WITTENBORG

TECHNICAL INFORMATION

TYPE NO	TYPE	T.I.-NO
FB 2800	**Freshbrew machines**	**. …02/02**

SUBJECT	ISSUED FOR (X):	
Change to brewer bracket	Action	
	Information	X

29578900 Bracket for brewer

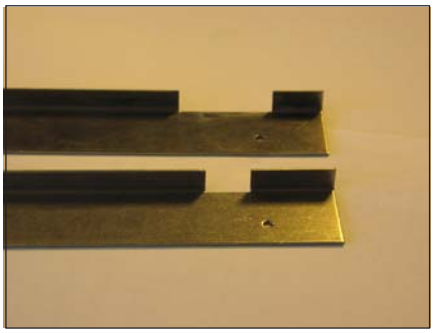
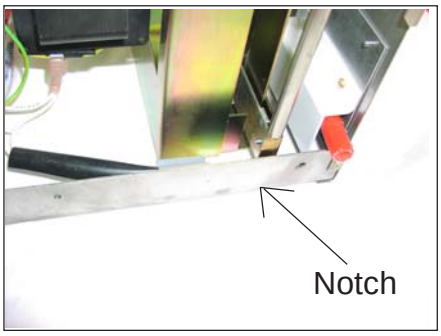
- From the above machine number the quadrangular notch in the reinforcement piece between the side parts of the brewer bracket has been changed to 2 x 10 mm.

- The quadrangular notch has been enlarged to prevent the wires for the safety switch at the brewer from being squeezed by the rod for yoke. The previous notch tended to bee too small thus causing damage to the wire insulation during time.
